Presentation to the Independent Planning Commission
Hills of Gold wind farm

Supporting material to my verbal presentation

Danielle Douglas

NAD_22

Corners B1 and B2

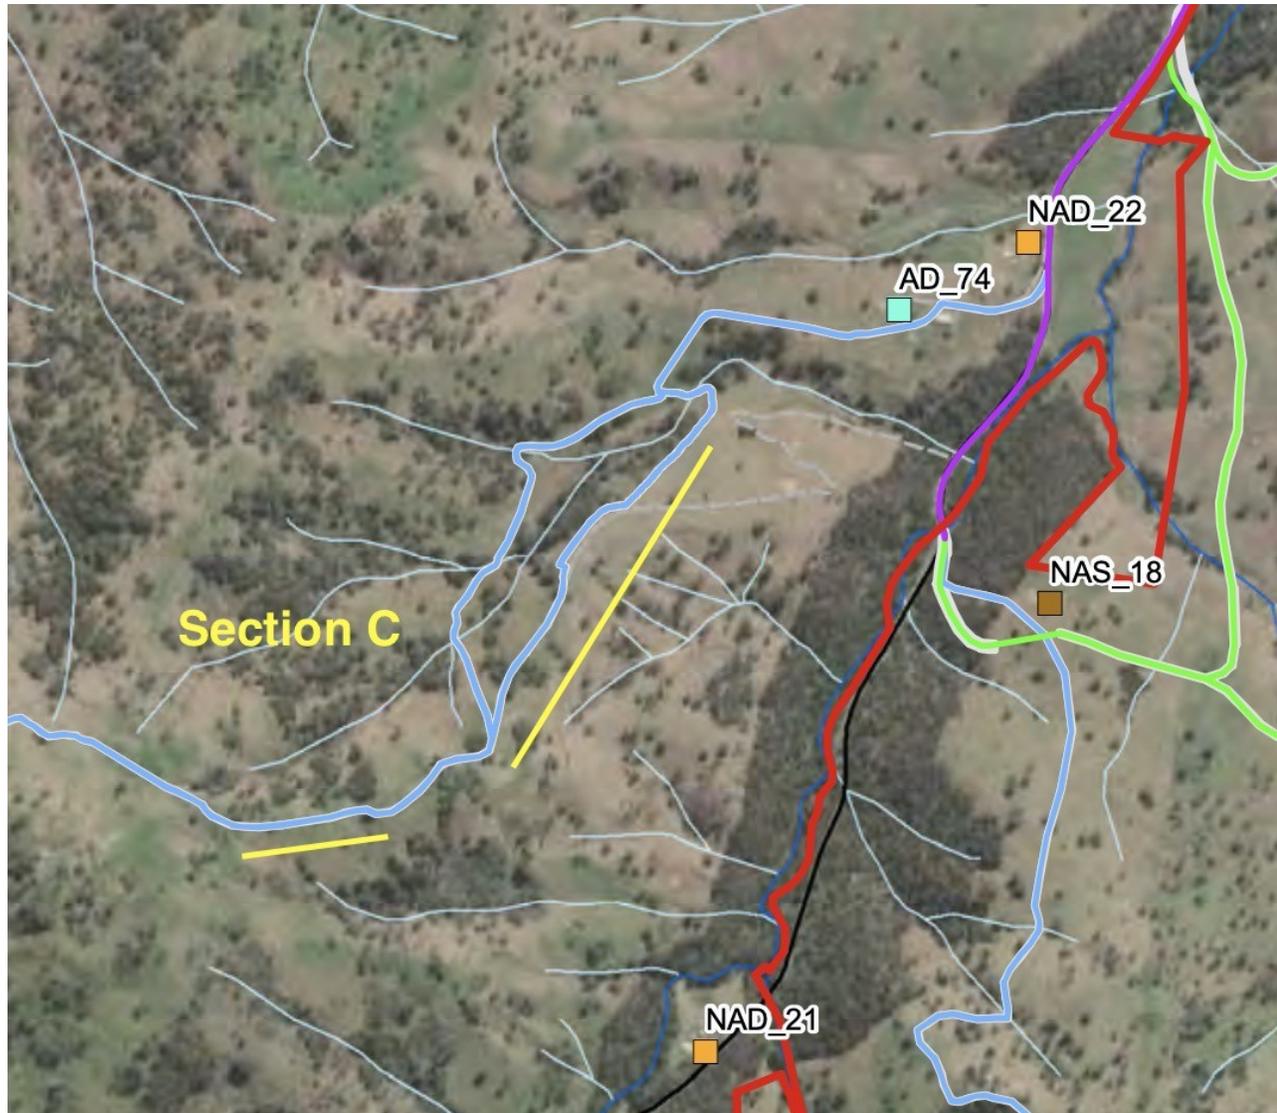
At the front of our house we marked it as Corner B1 and B2, this is where there is a possibility of trespass by the neighbor's driveway, which is proposed to be used by the Applicant for accessing the wind farm power line. The use of this access point will have a huge impact on our dwelling with light and heavy vehicles passing our house in close proximity. We also need to make sure that no trees located on our private property are cut, lopped or damaged by the large trucks accessing the power line.

We don't know how well the old fence is aligned with the boundary. We are asking the Commission to make it a condition that the Applicant survey these two corners.

Additionally, we would like the commissioners to impose the following conditions in relation to the use of this driveway in front of our house. No construction traffic earlier than 8:30 or later than 3 pm, and dust suppression measures or sealing to be implemented to prevent the dust from settling on our roof, silting up our gutters and rain water tanks.

Access to powerline construction vehicles
Trucks with wire spools and tower sections
Electrical components
Gravel and cement tracks
All meters within our home

- Survey the corners
- Time of use/construction hours
- Dust suppression

Section C

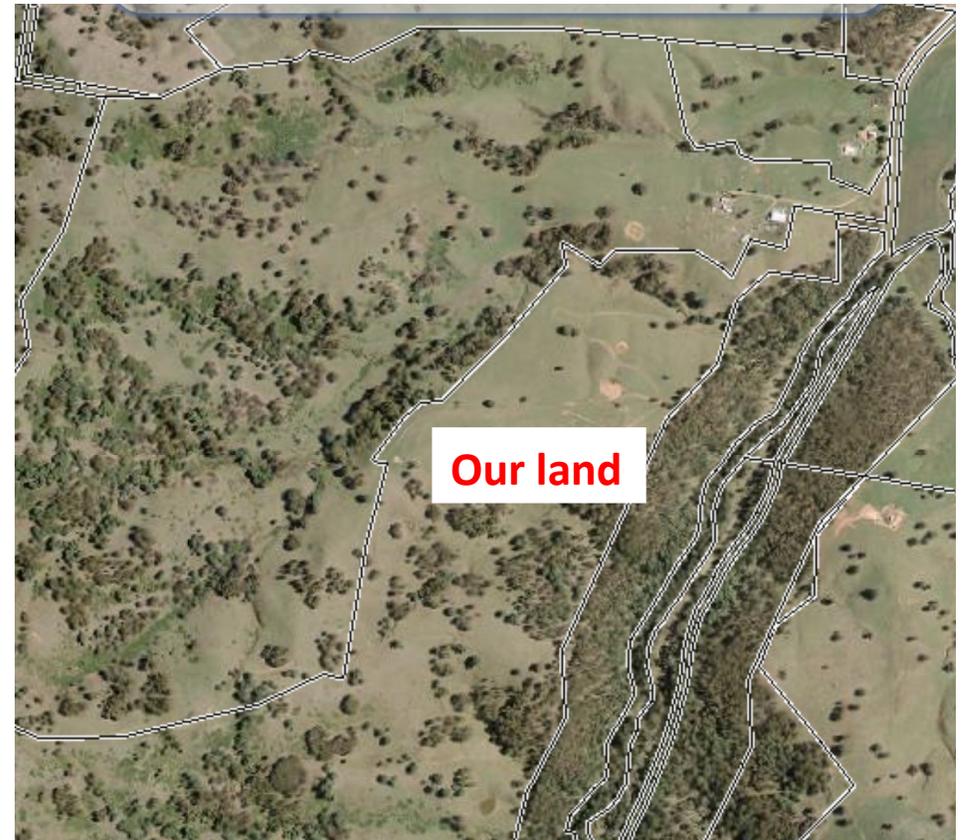
Looking at the maps provided by the applicant, it seems they may need to enter our paddock at section C because the land on the other side of our fence is very steep. There is not much room for a track there which is why our neighbors enter and cross our paddock especially in wet weather. Again, we would like to make sure that the wind farm power line construction traffic does trespass on our land. This is another section where we would like the Applicant to do the survey to make sure that any tracks constructed are not on our land.

It appears that in some areas the power line construction access tracks are following our boundary very closely, or even trespassing.

Survey the boundary

Figure B.1.1.2. Transmission Line (Option 1) Photomontage PM01 (Representative of AD_74)

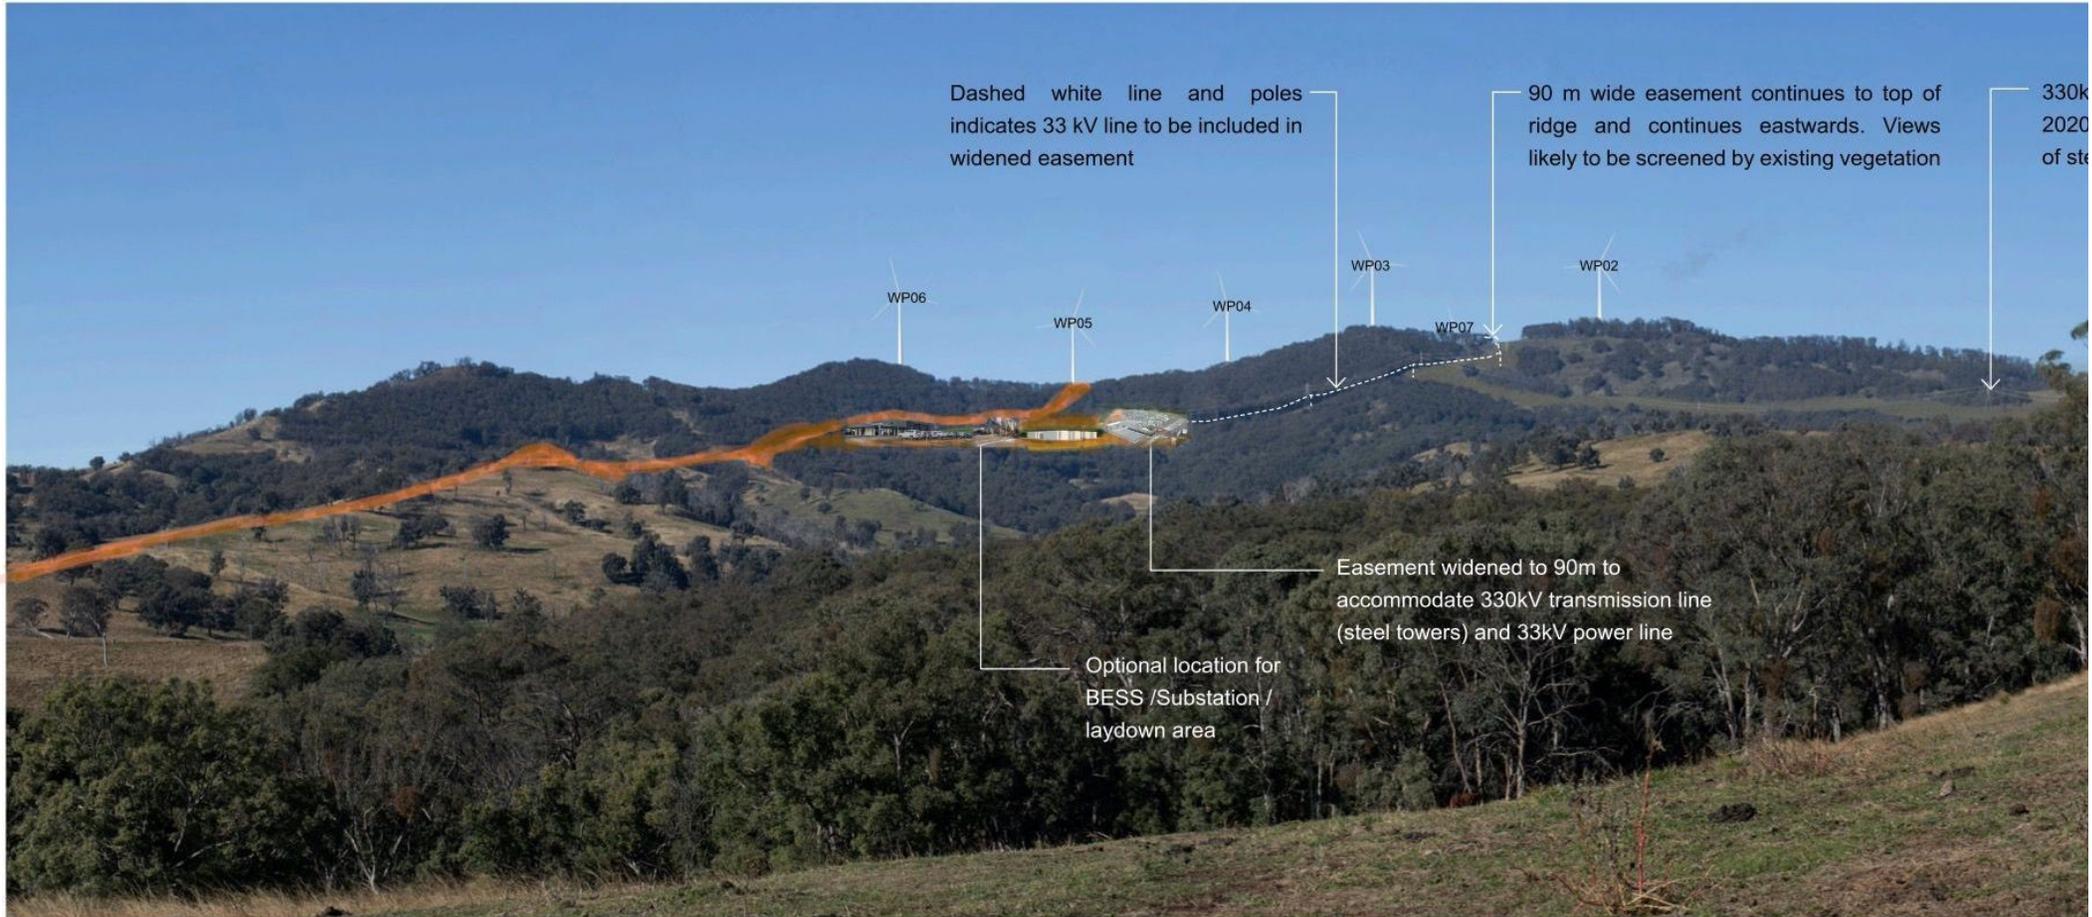
The Applicant has provided Photomontage PM01 to demonstrate the visual impact of the turbines and the power line corridor. They have **never** presented the visual impact of the Western access track to the development corridor (orange line) nor the big Battery bank, Concrete batching plant, Operations building and the Substation, all located on the shelf below turbine 5. A community member has added these element to the Applicant's base picture to demonstrate the visual impact. **This is our visual impact.** This photomontage represents the view from the paddock next door, **200 meters from our house.**
